ENVIRONMENTAL ASSESSMENT REPORT

**ROADSTONE DUBLIN LTD. LANDFILL SITES AT
BLESSINGTON, CO. WICKLOW**

BLESSINGTON & DISTRICT FORUM

Report by TMS Environment Ltd.
Report Ref. 8236-2 Revision 1.0
12th May 2005

Figure No. 2

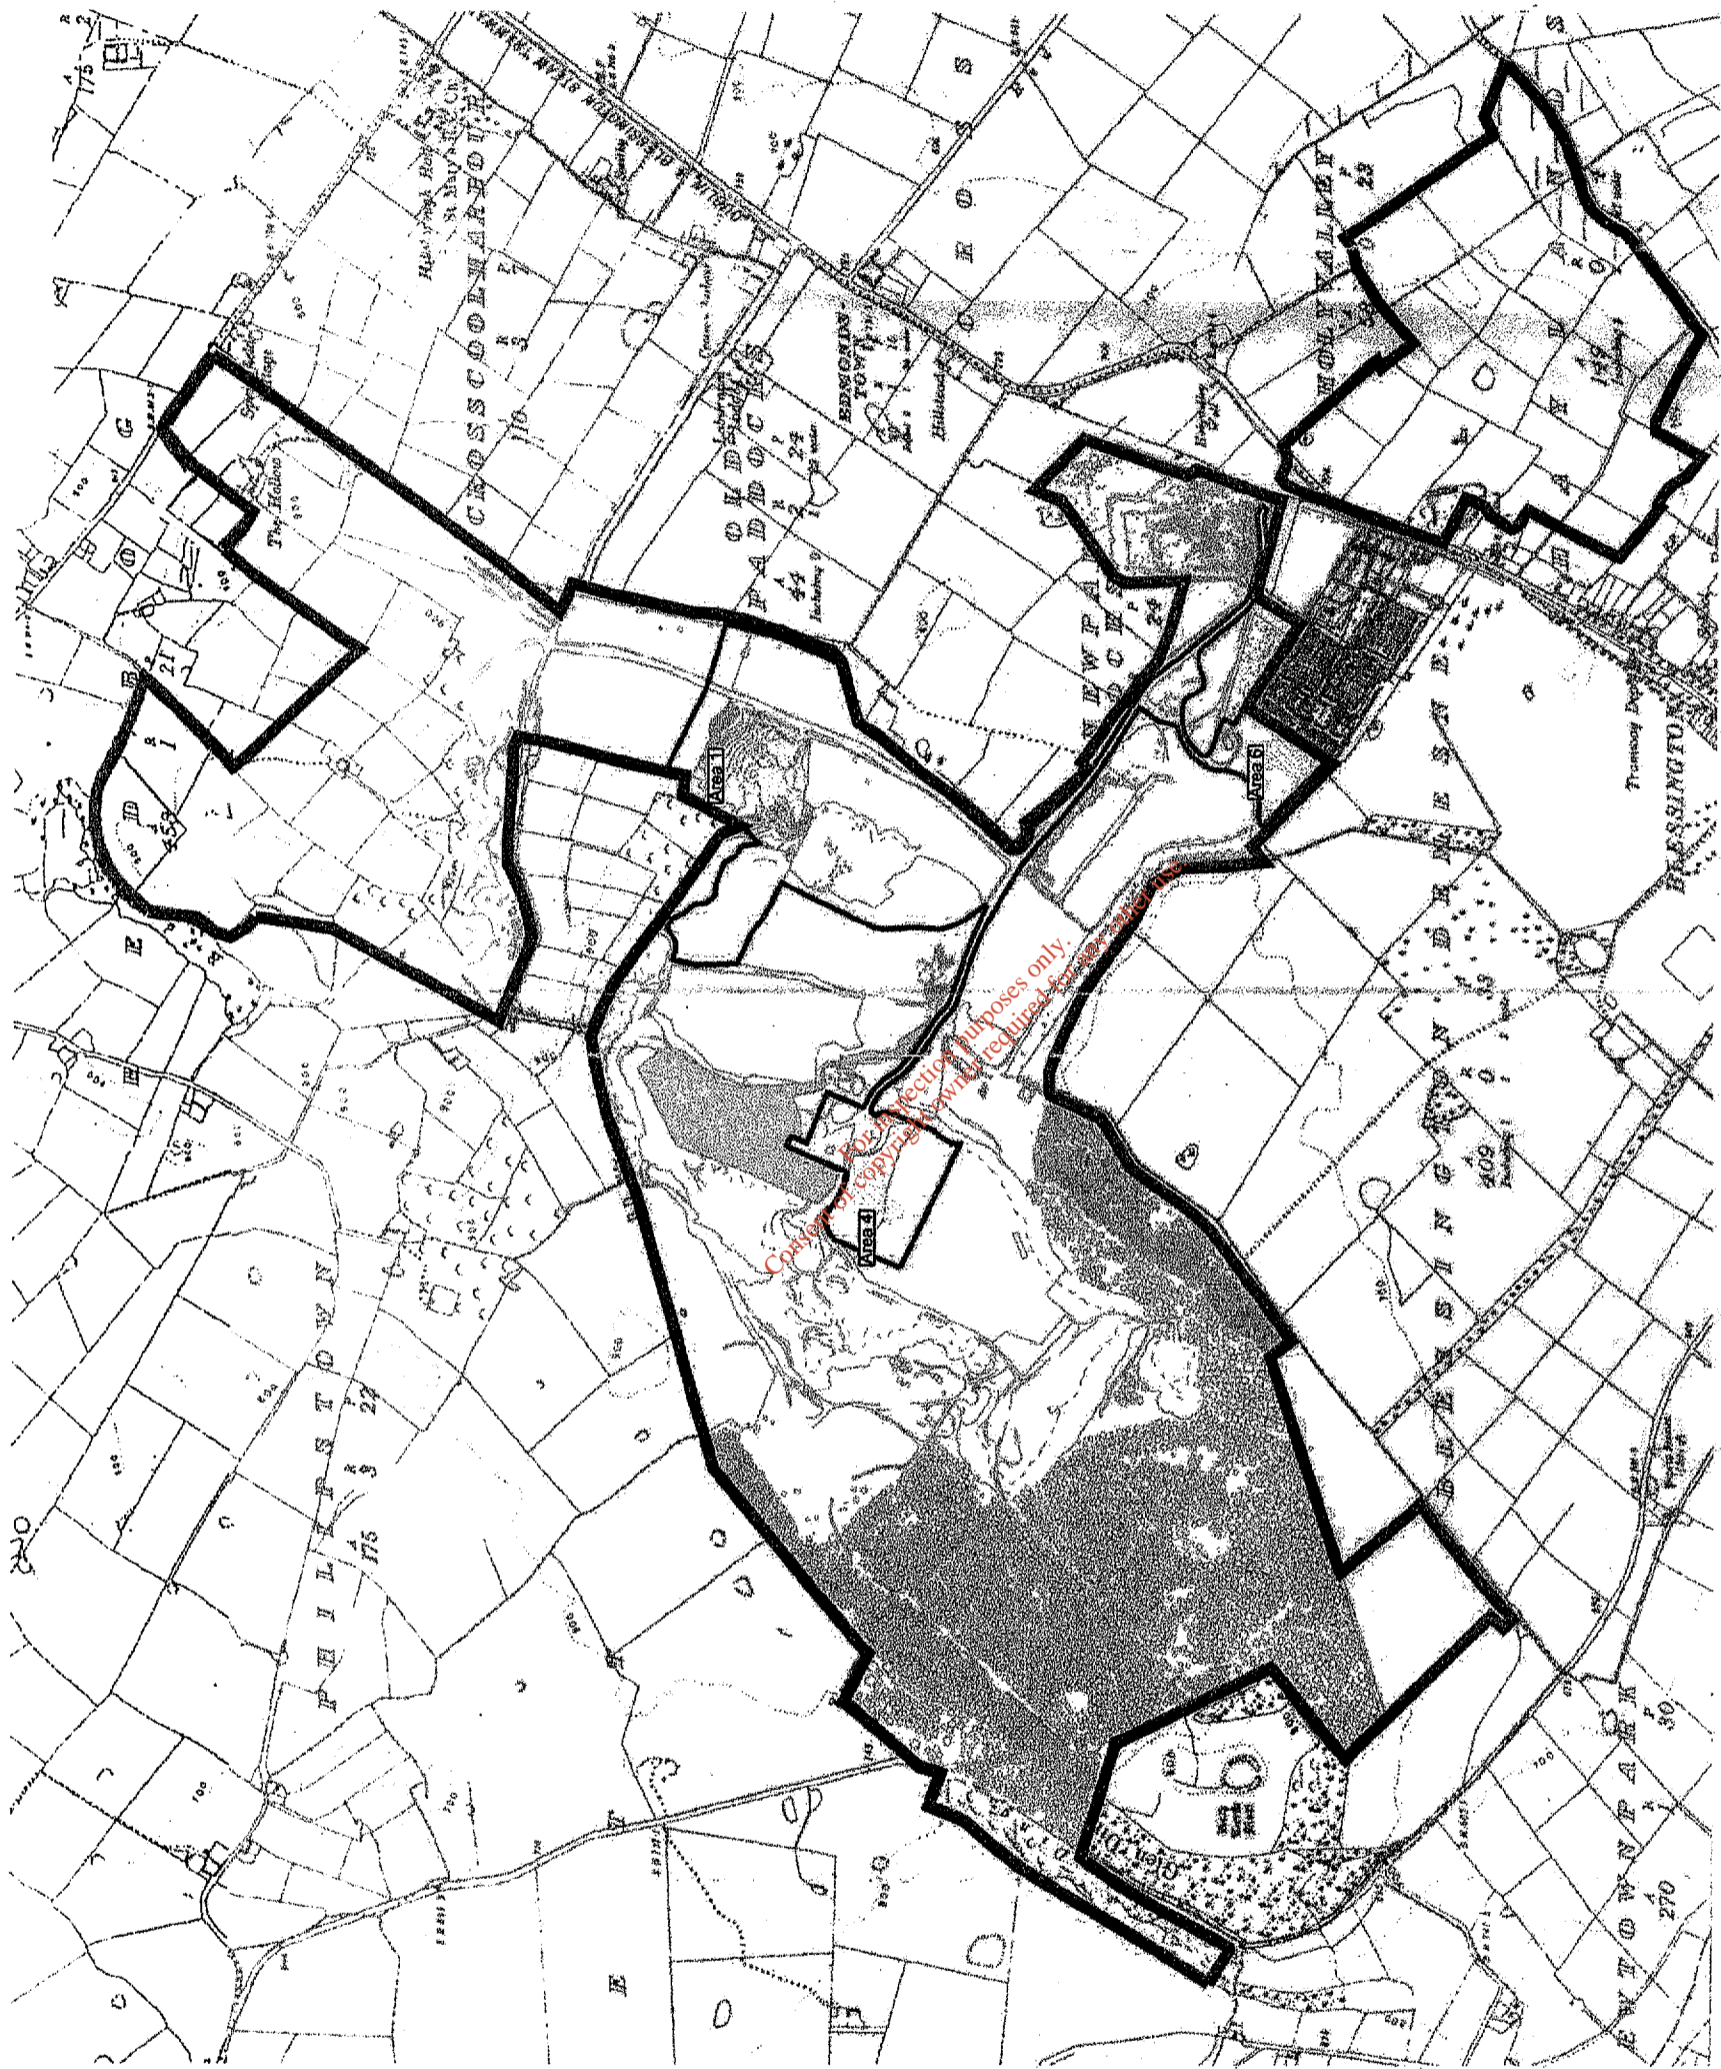
Roadstone Dublin Ltd own and operate extensive aggregate extraction activities at a large site on the outskirts of Blessington, Co Wicklow. The site location and the extent of land ownership is shown in Figure 2 which is reproduced from the Roadstone Dublin Ltd Environmental Impact Statement for the proposed remediation project which is reviewed in this report.
